From: Stan Sims <stan@stansimslaw.com>
Sent: Wednesday, November 2, 2022 11:35 AM
To: St Germain, Dante
Cc: john@bardlaw.com
Subject: RE: 22-0057 and Stan Sims

Please do not approve 22-ZONE-0012 and 22-ZONE-0076. The karst report and the geological report support the development will alter the terrain, the water, and cause new sinkholes / caverns. The property in question is not suited for development and will cause undue harm and risk to my home, my family, and my neighbors.

The proposed massive development at 4700 S Hurstbourne Pkwy violates several Plan 2040 Plan Elements and staff checklist. I am deeply concerned about what this means for my home, my family, and my community.

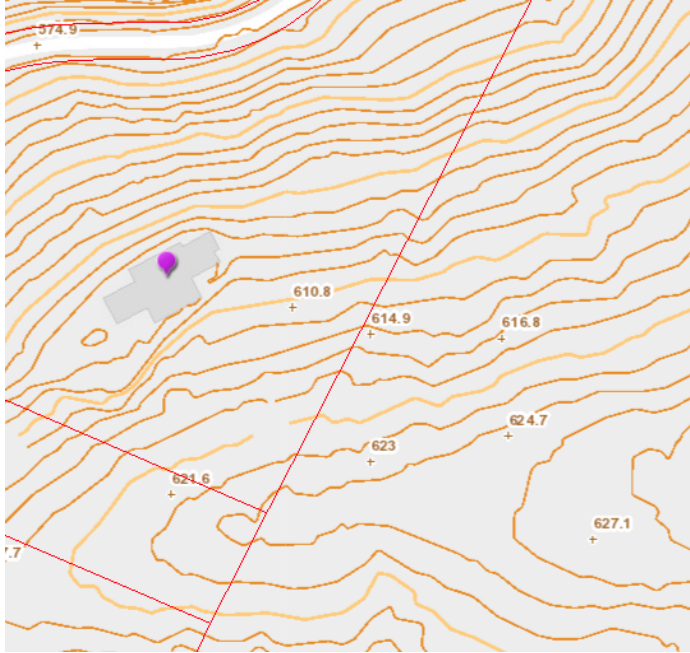
- According to section renderings, these massive 55-foot buildings are on land that is already 10 to 15-feet higher than adjacent properties. There may also be an additional 8-feet of backfill required (per geotechnical study and neighborhood meeting). Thus, these buildings will appear 78 feet to us who live below. See figure 3.1.

- For an *additional* 100-feet to be added to the setback along the North (Laurel Springs) and West (Walnut Hills Dr) sides of the property.
- Include a 6-foot berm with a 6-foot privacy fence and trees around the entire perimeter of the development at 4700 S Hurstbourne Pkwy and 4900 S Hurstbourne Pkwy.
- Leave the natural buffer along Laurel Spring Dr alone. See figure 3.4.

Figure 5.1 - 4700 S Hurstbourne Pkwy underground stream exiting at cliff 4819 Walnut Hills Dr (left), approximate location of sinkholes according to developer's plans, and the approximate location of sinkholes on abutting properties (right).

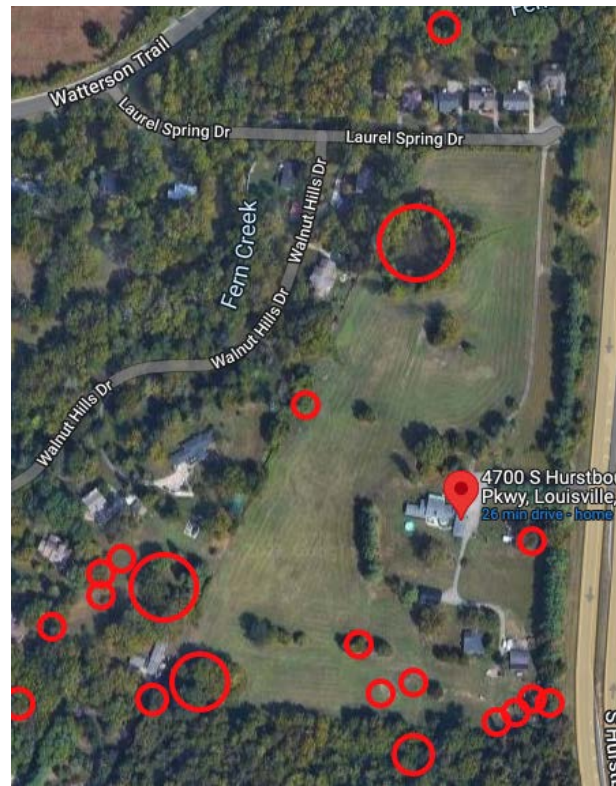
- There are sinkholes on abutting properties that are very close to the property line that the engineers failed to identify. In fact, we have reason to believe that one of these may be an underground cave or stream that flows from the 4700 S Hurstbourne Pkwy property, beneath a residents house, and ends up in the protected creek below. See figure 5.1

- For an unaffiliated third-party to conduct a geotechnical / impact study on the adjacent Walnut Hills and Laurel Springs properties.

Figure 5.3 - Fern Creek is a FEMA Regulatory Floodway

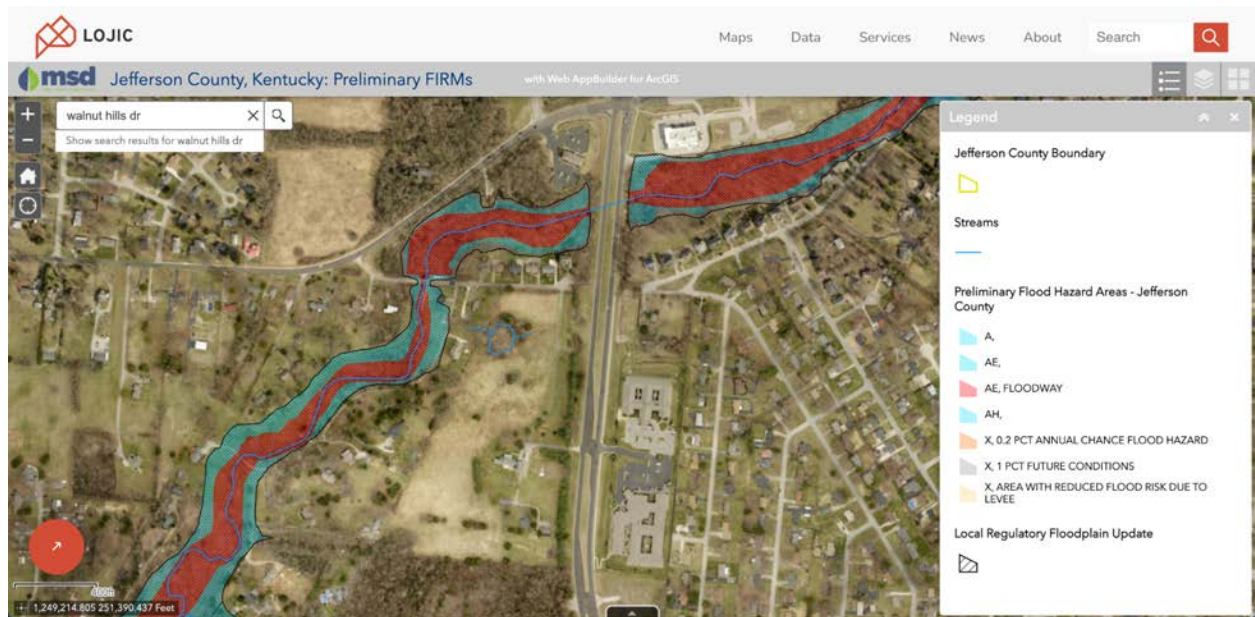
- According to Lojic Online, 4700 S Hurstbourne Pkwy is nearly surrounded by steep slopes, unlike any other development on Hurstbourne. See figure 5.2
- Due to our waterway being a FEMA Regulatory Floodway, surrounding properties are to be further regulated (according to FEMA). While the developer's property does not directly abutt to the creek, every single-family home surrounding it does. See figure 5.3
